tion No. 170 (Child Restraint Systems for Safer Transport of Children in Buses and Coaches)

Submitted by the Informal Working Group on Safe Transport of Children in Buses *

The text reproduced below has been prepared by the Informal Working Group on the Safe Transport of Children in Buses to align the text of the UN Regulations covering adult and child safety. The modifications to the current text of the UN Regulation are marked in bold for new or strikethrough for deleted characters.

Figure 13
Strapped-in Child

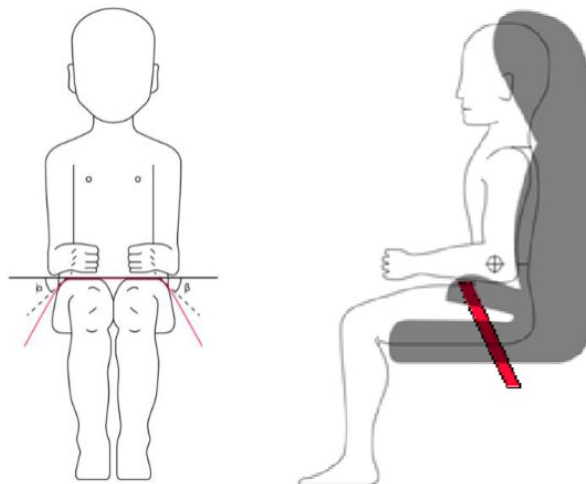
In the case of non-integral Child restraint Systems, the lap portion of the adult safety-belt shall be positively guided on both sides to ensure that the loads transmitted by the adult lap belt are transmitted through the pelvis. The positive guidance of loads over the pelvis shall be realized from the moment that the child is installed; the lap belt shall pass over the top of the thigh, just touching the fold with the pelvis. The angles α and β between the tangent line in which the belt touches the thighs and the horizontal shall be greater than 10° as show in in figure 43.

Figure 24
Arrangement for Testing a Forward-Facing Device

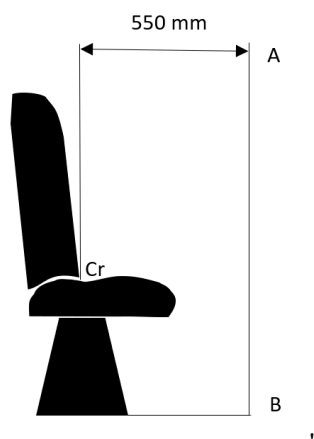
"8.3.6.6.1. No part of the head of the dummy shall pass beyond the planes BA as defined in Figure 24 below.

8.3.6.6.1.1. Where a test is conducted in accordance with paragraph 8.3.4.2. above, a tolerance of +10 per cent shall be applicable to the head excursion value distance between Cr point and plane AB.

Figure 35
Examples of Arm Alignment

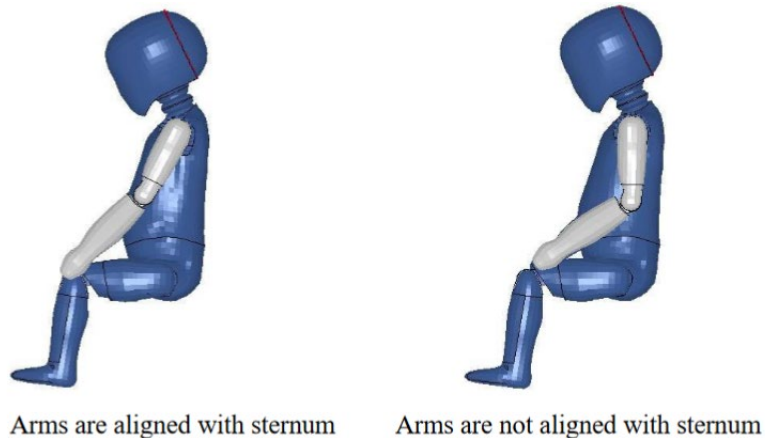
"8.3.7.1.1.9.3. After installation. After installation, the dummy position shall be adjusted so that: The dummy center line shall be aligned exactly with the center line of Child Restraint System. The arms of the dummy shall be positioned symmetrically. Elbows shall be positioned in such a way that the upper arms are closely aligned with the sternum. Hands shall be positioned on the thighs. Legs shall be positioned parallel to one another or at least symmetrically.

Example for arm alignment is show in in Figure 35:

Figure 2
Measurement Device for Child Restraint Systems – Side and Front View of the Measuring Device

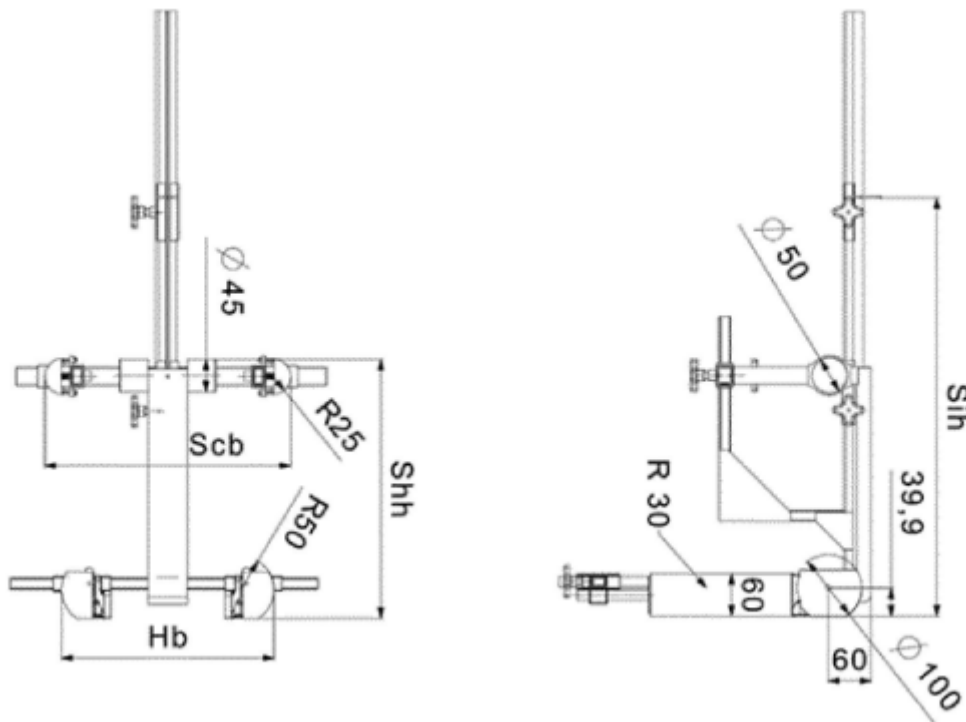
All lateral dimensions are measured under a contact force of 50 N with the devices described in Figure 2 and Figure 3 of this annex and the following tolerances will be applied:

The mass of the devices described in Figure 2 and Figure 3 of this annex shall be 10 kg ± +/- 1 kg.

1. The purpose of this document is to add some editorial corrections on the text.
2. The figures are renumbered for better consistency.
3. Adding missing figures for internal measurement devices.

"Example 2

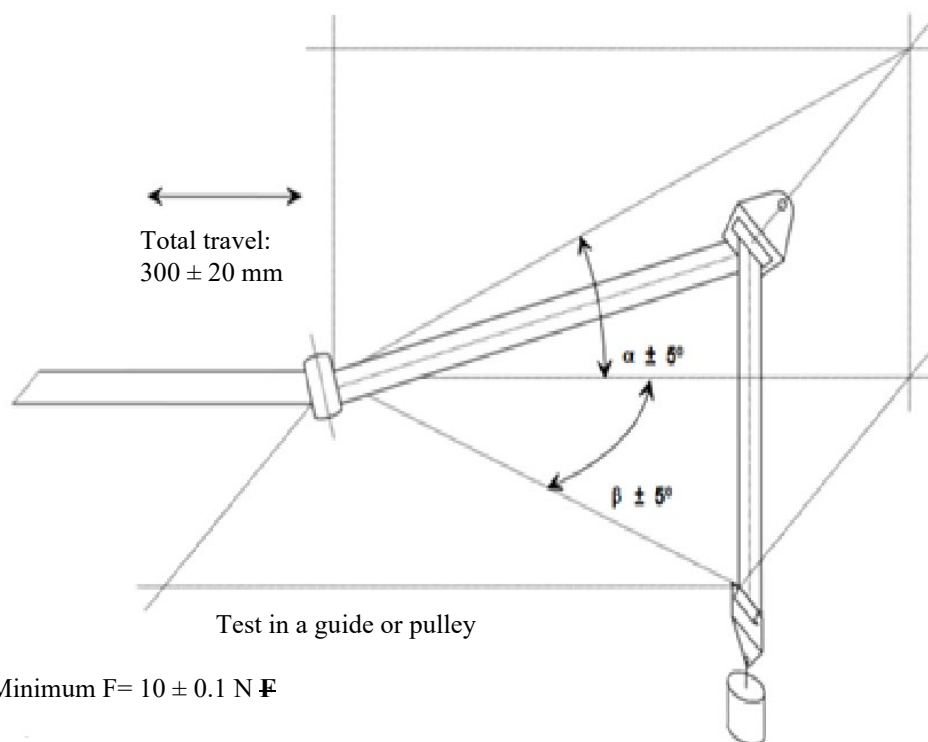
Annex 10, Figure 2, Example 2, amend to read:

Where α and β reproduce the angles as in the real installation (in the three dimensions)"
